U. S. NUCLEAR REGULATORY COMMISSION  
REGION I

REPORT NOS. 50-220/93-15  
50-410/93-15

FACILITY NAME: Nine Mile Point Nuclear Station Units 1 and 2

Area Inspected: This was an announced inspection to assess the reliability of the offsite power supply sources for the Nine Mile Point Units 1 and 2 and to review the licensee's corrective action on previously identified inspection findings on Unit 1.

FIGURE: 1

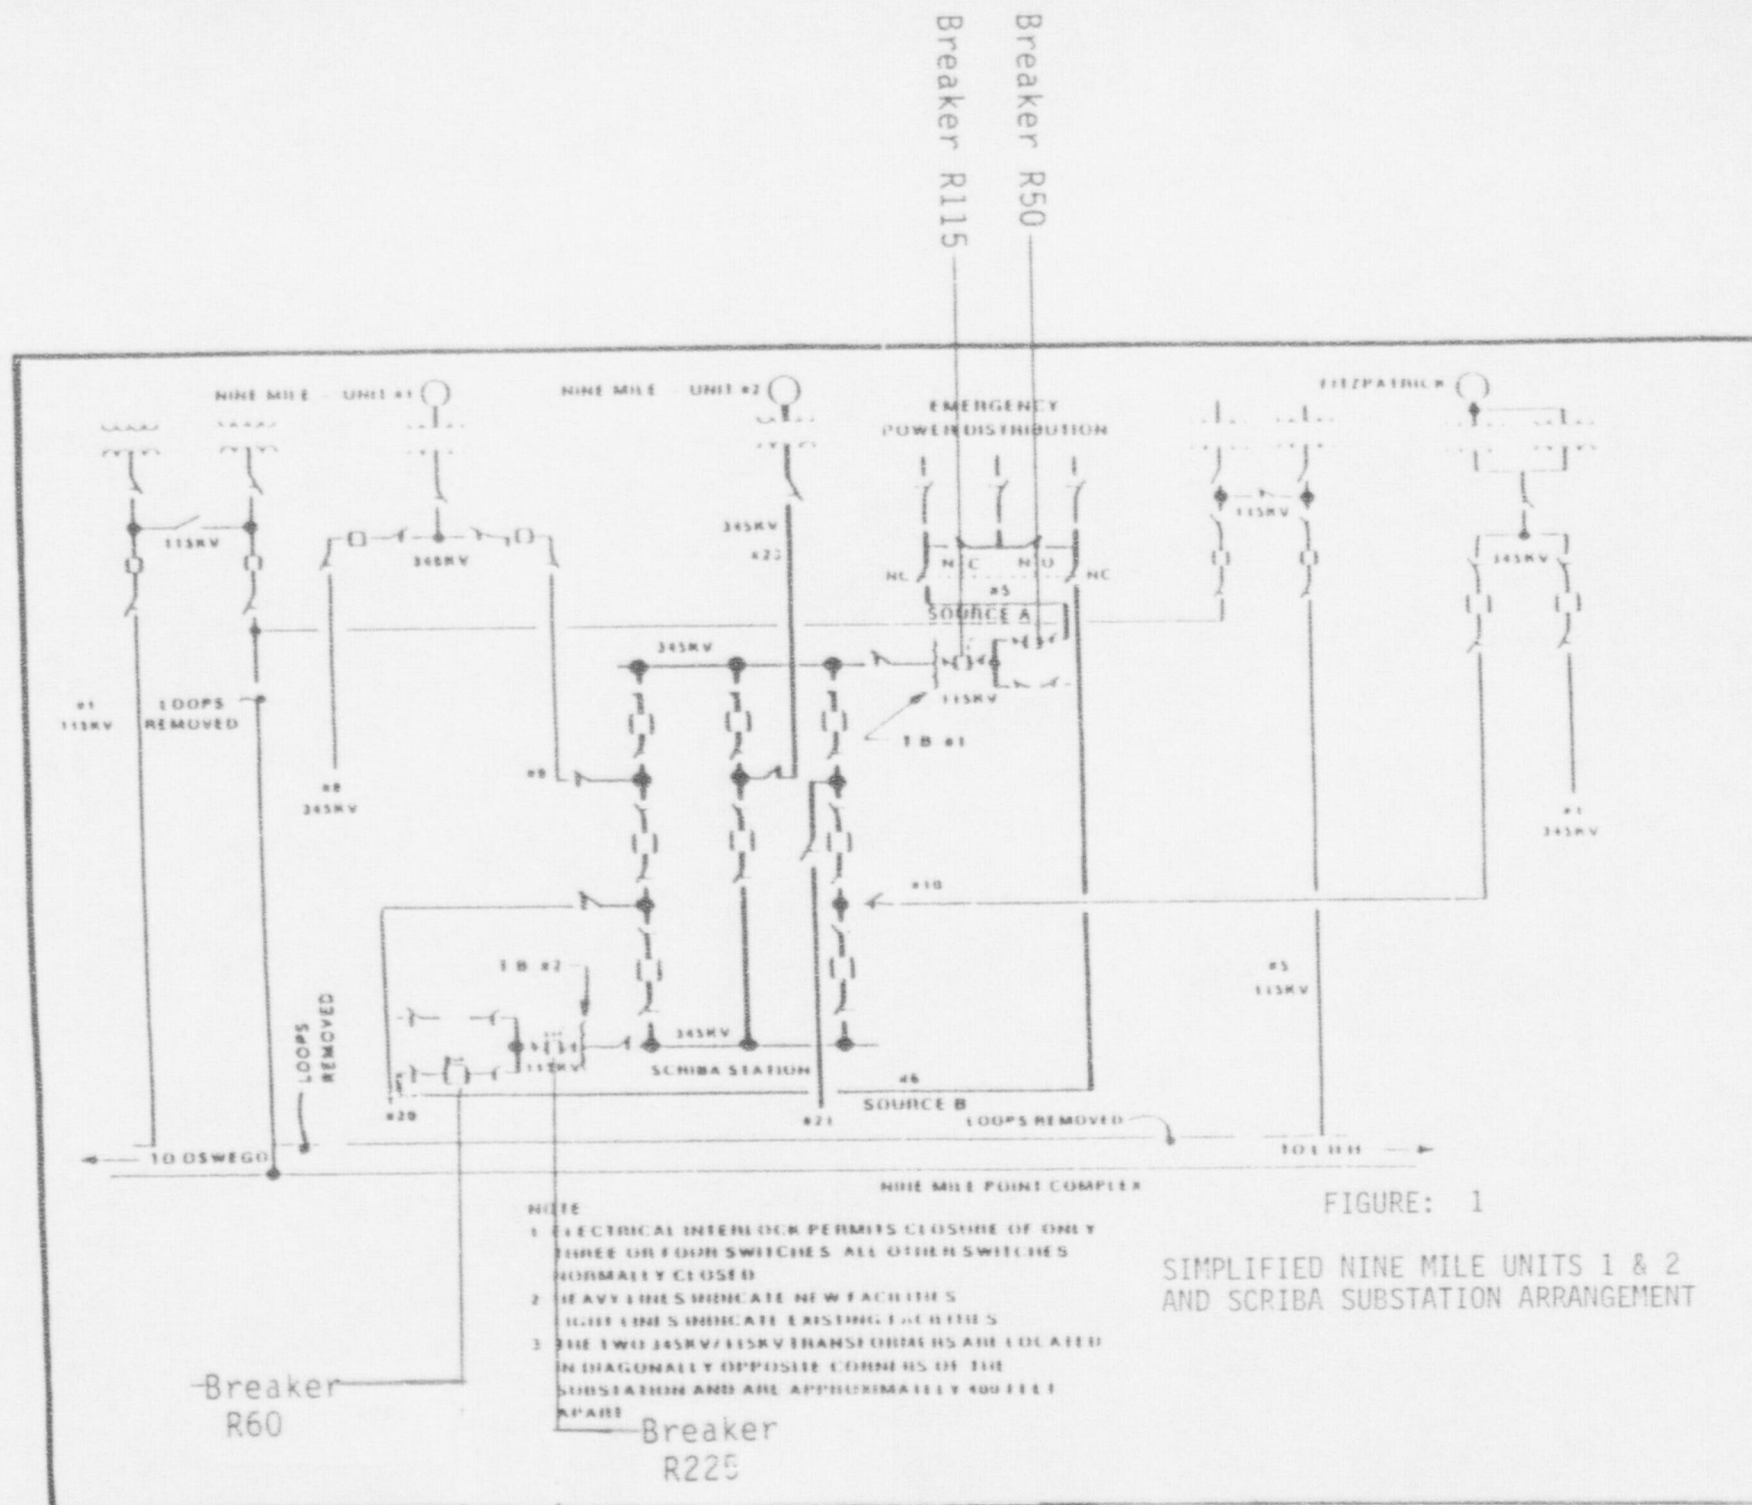
The Nine Mile Point Unit 1 main generator output is tied onto the grid via two 345 kV lines. Line 9 connects to the Scriba substation, approximately 0.41 miles from the site, and line 8 connects with the Niagara Mohawk Power Corporation (NMPC) cross state bulk power transmission system via the Clay station. During normal plant operations, unit non-class 1E auxiliaries loads are powered by the main generator via the unit service transformer. During plant startup, shutdown, and abnormal operating conditions, the station auxiliaries are supplied from the 115 kV offsite power supply system via the plant reserve transformers. The safety class 1E loads are supplied at all times from the 115 kV lines 1 and 4 which are not supplied from the Scriba substation 115 kV system. The simplified power supply arrangement is shown in Figure 1.

The Nine Mile Point 2 main generator output is tied onto the 345 kV Scriba substation, and the Scriba substation is further connected with two transmission lines to the Niagara Mohawk Power Corporation cross state connection link. During normal plant operation, the plant auxiliaries loads are supplied (via a step-down transformer) from the generator output. However, three 4.16 kV emergency buses are supplied from the two independent 115 kV offsite supply lines 5 and 6 from the Scriba substation. During plant startup and abnormal conditions, all loads (the unit auxiliary and emergency buses) are powered from the above two sources via two reserve transformers from the above two 115 kV lines of the Scriba substation. A simple arrangement of both units and the Scriba substation is shown in Figure 1.

The Scriba substation utilizes a breaker and a half scheme. The 345 kV buses in the 345 kV transmission lines are connected to the Unit 1, Unit 2 and two 345 kV transmission lines which feed onto the NMPC cross state power grid system. Two transformers (step-down voltage from 345/115 kV), located on diagonally opposite corners, provide two offsite power sources to NMP2. A simplified diagram depicting the general arrangement and other equipment associated with the Scriba substation is shown in Figure 1.
